CITY OF WEST LAKE HILLS, TEXAS
NOTICE OF BOARD OF ADJUSTMENT (BOA) REGULAR MEETING
Wednesday, September 10, 2025 at 7:00 PM

3. Consent Agenda Discuss and consider action to approve the August 13, 2025 Regular Meeting Minutes.
4. Land Use 1801 Basin Ledge - Discuss and consider action on a recommendation from ZAPCO on proposed variances

5. Land Use 912 Calithea Road - Discuss and consider action on recommendations from ZAPCO on proposed variances:

6. Land Use 217 Reveille Road - Discuss and consider action on recommendations from ZAPCO on proposed variances:

Request:

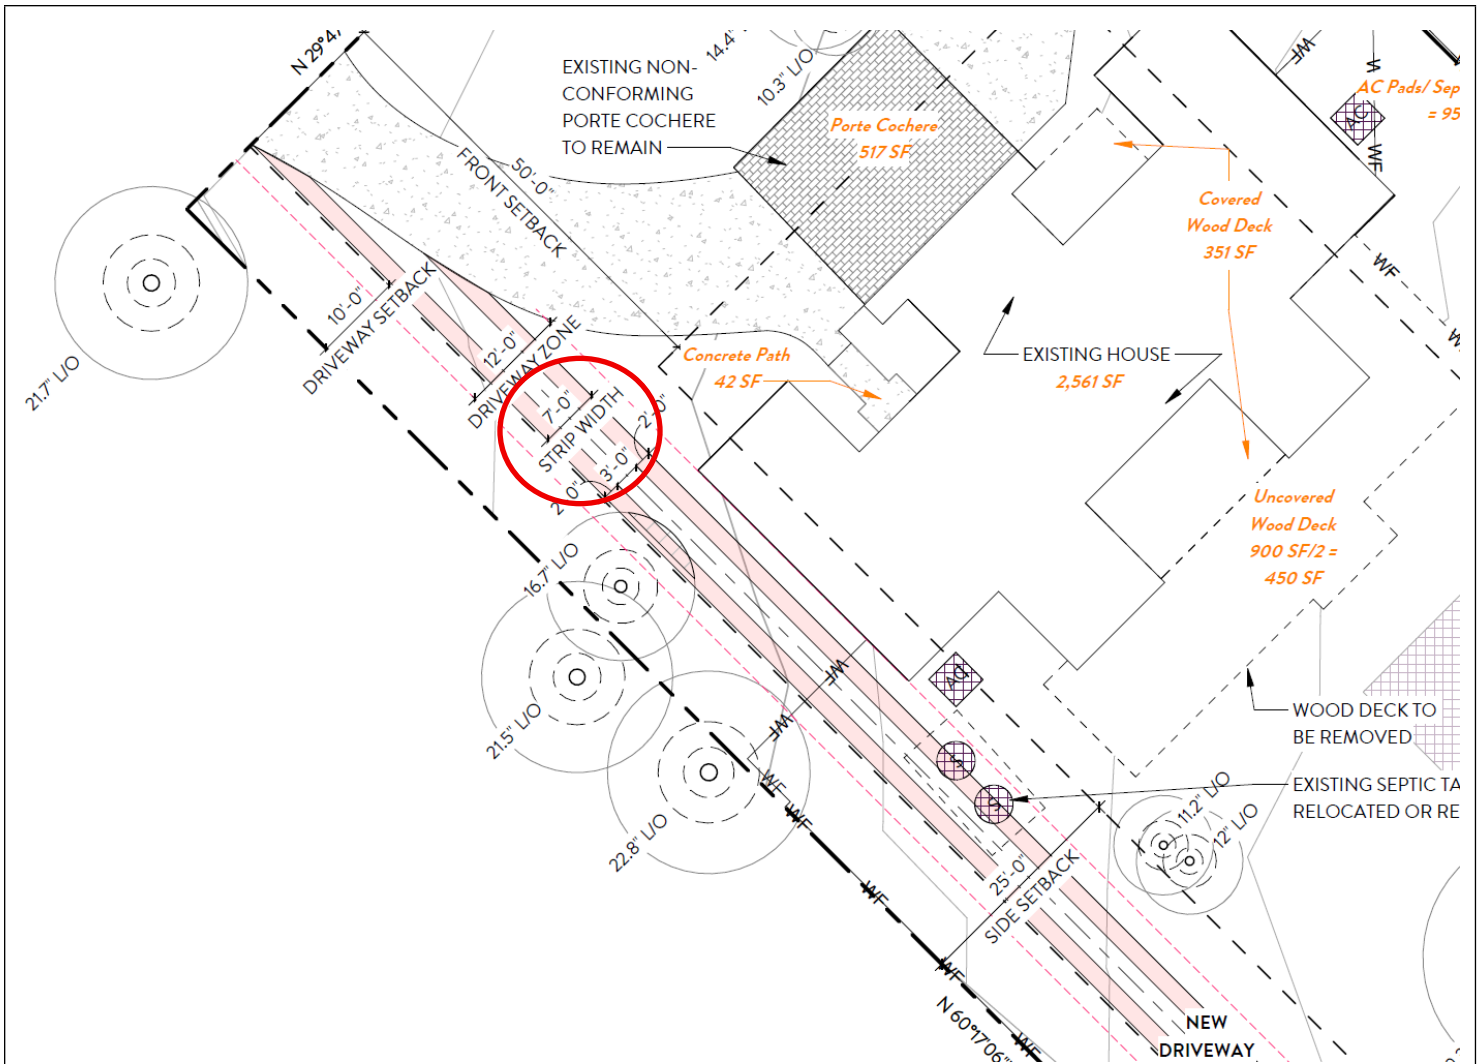
To construct driveway wheel strips that provide 7 feet of driving surface width.

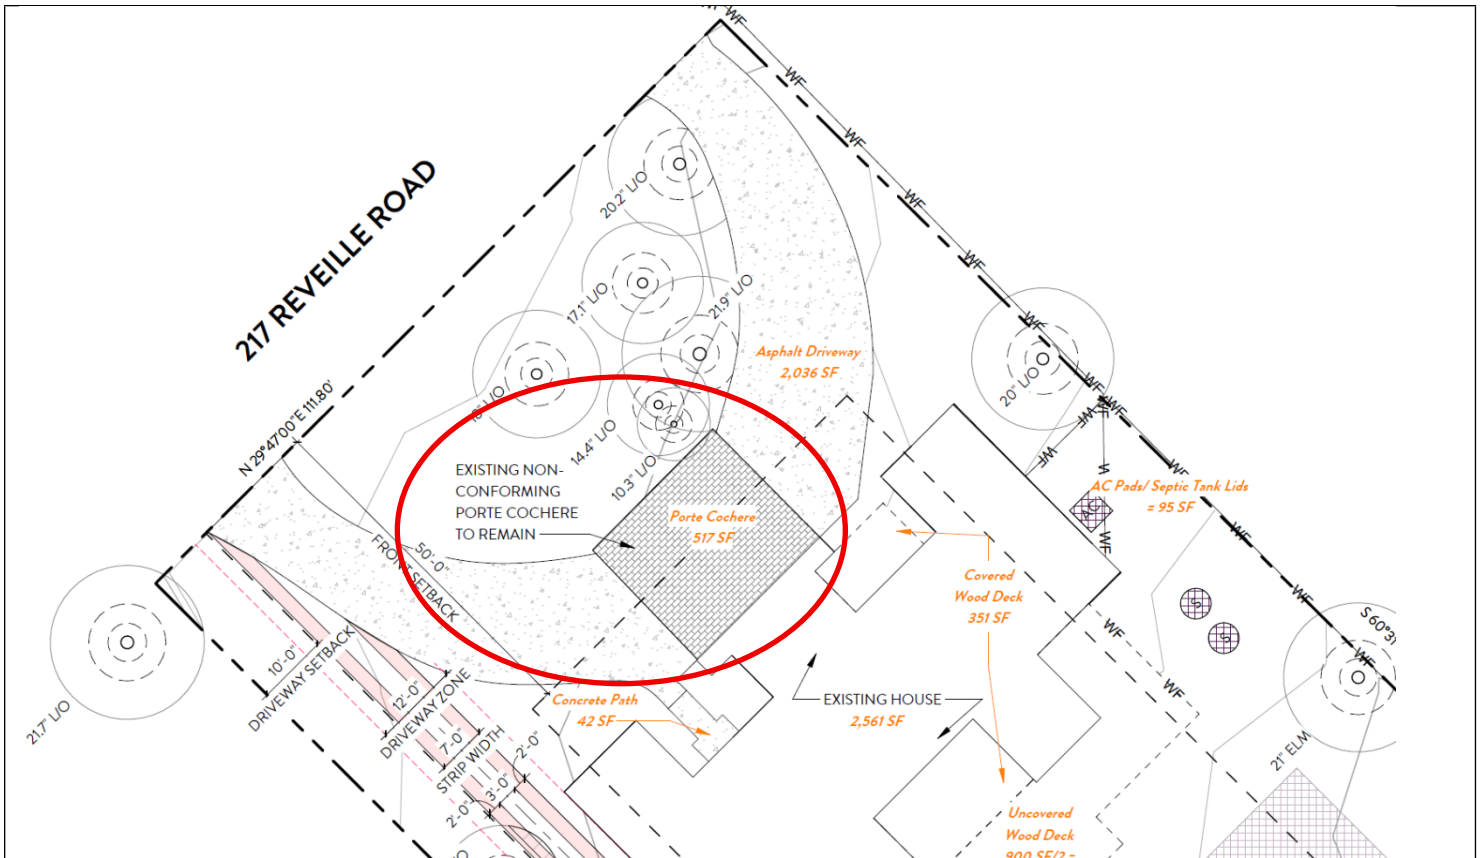
The applicant is requesting to keep the non-conforming driveways and extend one of the driveways to the back of the property.
